ADDENDUM NUMBER 02

PROJECT: **GTC – Greenville – Bldg. 103 Bookstore Expansion**
GMC PROJECT NO. AGRE200029
OSE PROJECT NO. H59-N046-PD

A1 WALL GRAPHICS
SCALE: 3/4" = 1'-0"

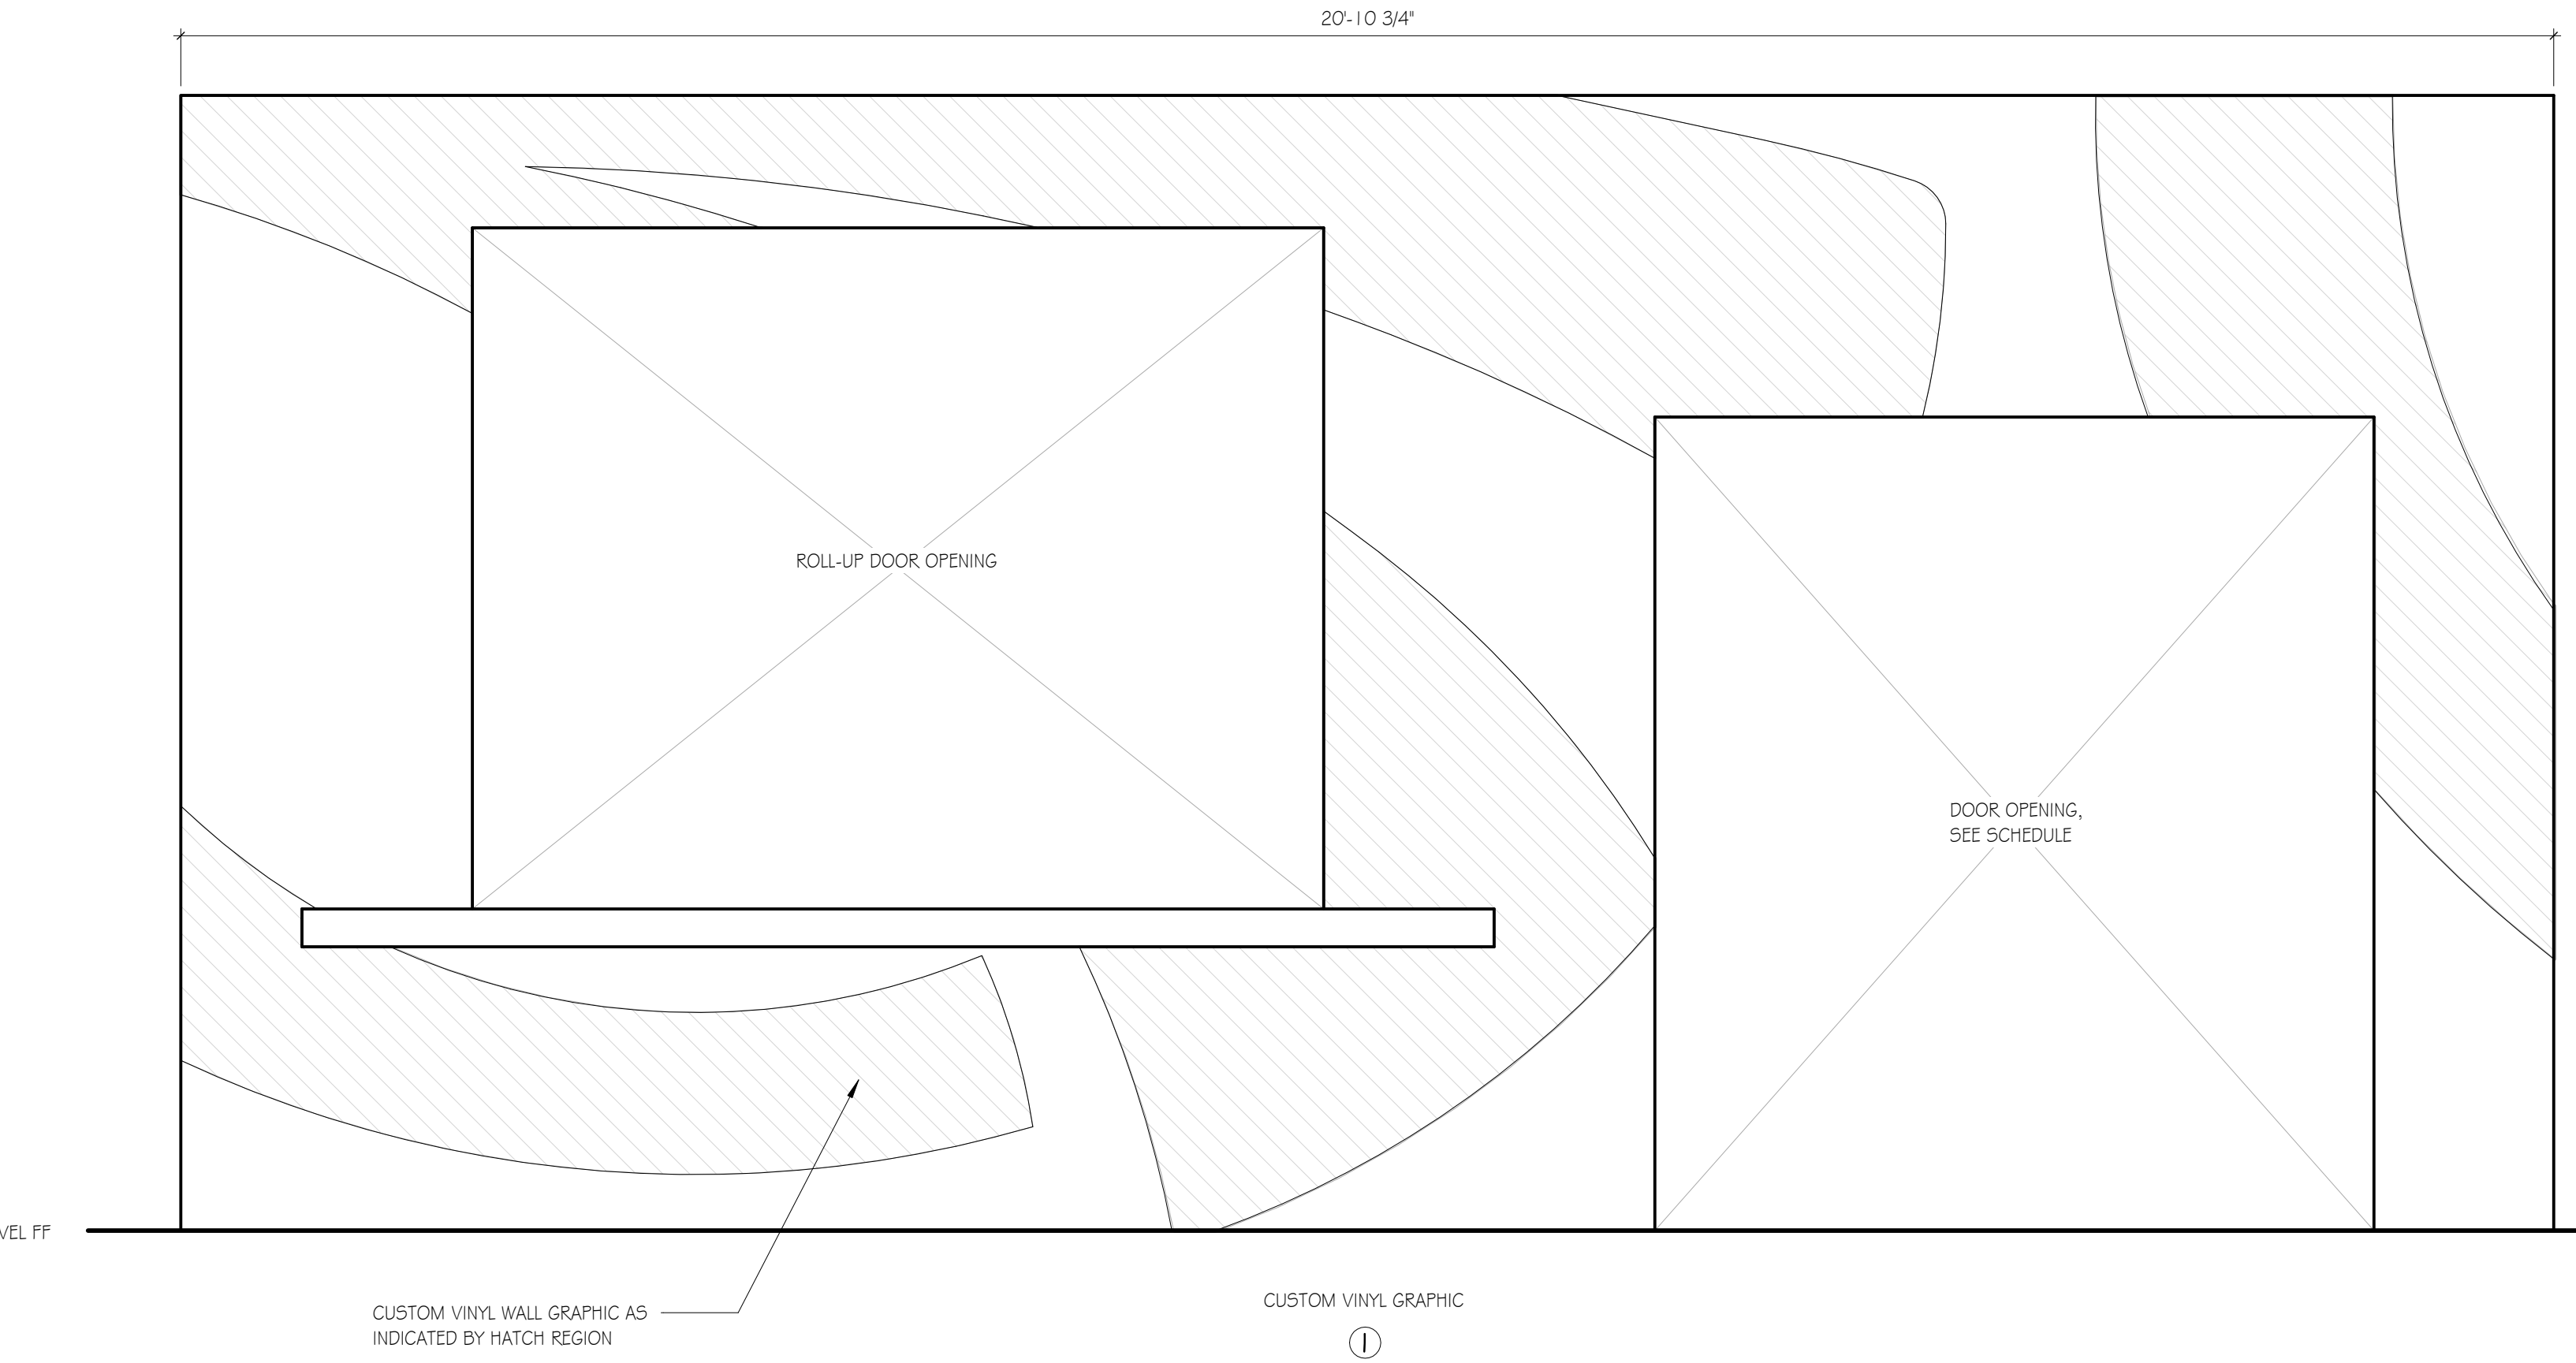
- A2Q23 Can a specification be provided for the custom vinyl wall graphics shown on A8.01? If not, could a material allowance be given? **Reference A8.01, Architect to provide wall graphic image CAD file during submittal process. Assume \$3,000 for vinyl graphics package**

ARCHITECT TO PROVIDE WALL GRAPHIC IMAGE CAD FILE DURING SUBMITTAL PROCESS
